GROUP	MODEL
ELE	2024MY EV9 (MV)
NUMBER	DATE
336 (Rev 1, 7/10/2024)	April 2024

TECHNICAL SERVICE BULLETIN

SERVICE ACTION: INTEGRATED LED HEADLAMP CONTROL UNIT OPERATION LOGIC IMPROVEMENT (SA567)

736.MV1 ILCU_L Operation Logic Improvement

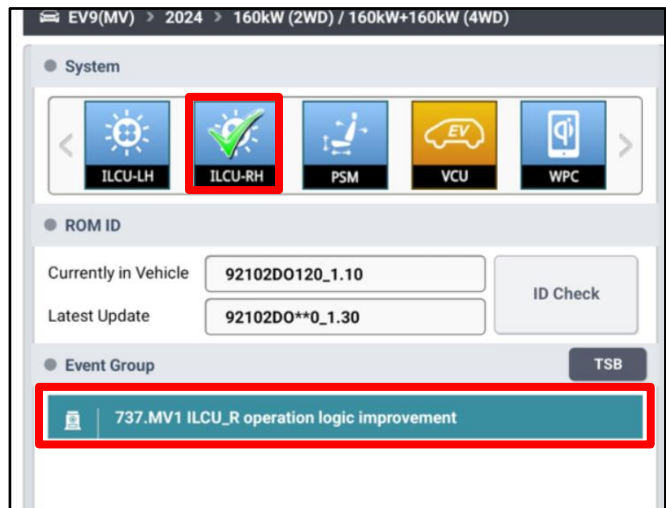
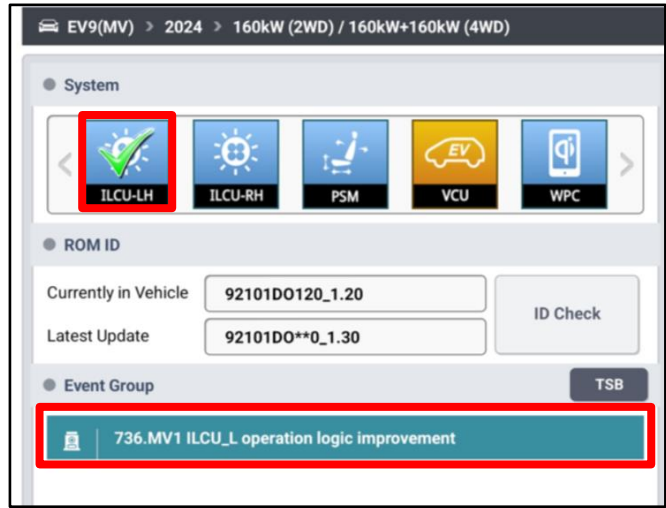
Refer to [TSB SST081](#) for instructions to upgrade the 'ILCU' system:

737.MV1 ILCU_R Operation Logic Improvement

Both events 736 **and** 737 **MUST** be completed. 'Fault Code Searching' is not required after events 736 and 737 have successfully completed.
